TE Connectivity

Product Change Notification: P-19-018244

MCON 1.2 LL SWS

Explanation for two new duplication production tools 11-1942306&11-1942218 for Mcon1.2 LL

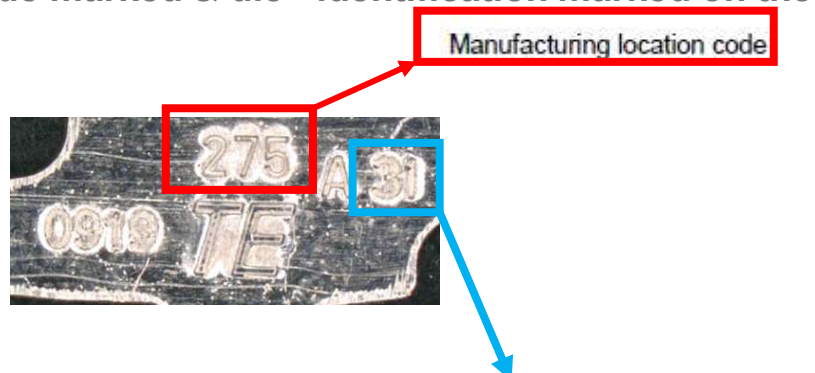
1. For China local customer requirement on Mcon1.2 LL, two new duplication production tools (11-1942306&11-1942218) in TE Suzhou plant for production to support only Asia-Pacific market. For this new duplication production tool , it will shorten the L/T of delivery time and offer good service for Asia-Pacific market .
2. The identification of Suzhou production part is that there are “T275” manufacturing location code marked & die - identification marked on the part as below:

Manufacturing location code

Number code of production tool

DIE-INDEX Wkz-Kennz.	DIE-NO. Werkzeug-Nr.
31	11-1942218
32	11-1942306
